**WINNIPEG SEWAGE  
TREATMENT PROGRAM**

**SOUTH END PLANT**

PAGE 1/17	<b>ANSWERS TO EAP PRELIMINARY REPORT</b>
--------------	--

Following the reception of the preliminary EAP report, the Program prepared and forwards to the EAP the answers to its questions.

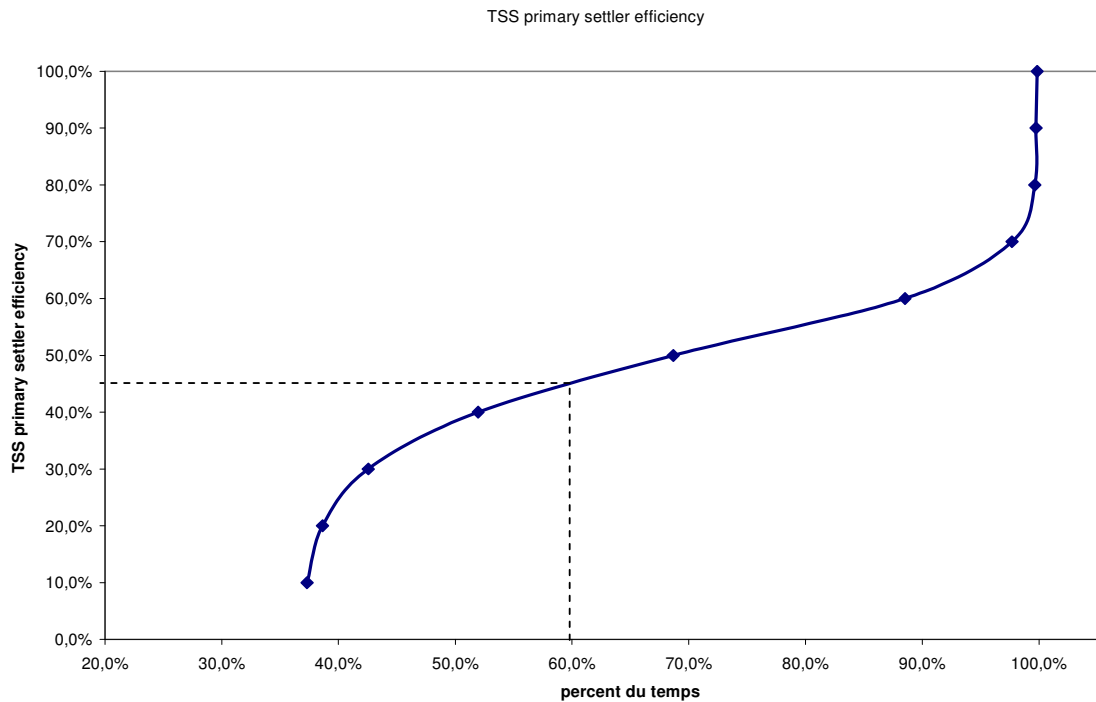
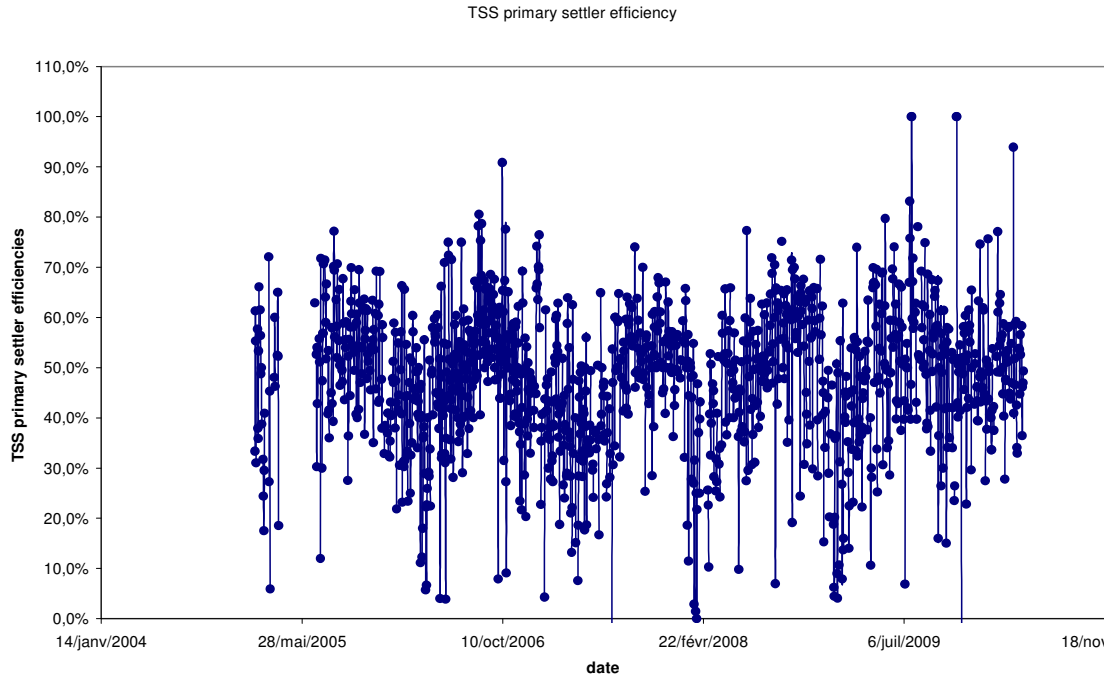
*C2 : It is not clear at all what is the basis of predicting any of these removal efficiencies at maximum month conditions. The reported values do not agree with the operator stated baluers and need to be verified. These low removal values have a profound impact on the biological portion of the plant. Higher primary effluent TSS will increase the mass of inert and unhelpful organic material in the biological reactor, thus requiring a higher MLSS concentration to achieve equivalent treatment performance.*

**P2 :** The explanation of these removal efficiencies is as given below :

The efficiencies on the primary settlers have been estimated from actual results on existing primary settlers and considering that the velocities will be increased a little bit. The quality of the water (very diluted water) is also considered in the efficiencies calculations. See, here below, the results on TSS efficiencies on existing primary settlers during last five years and the percentile curve:
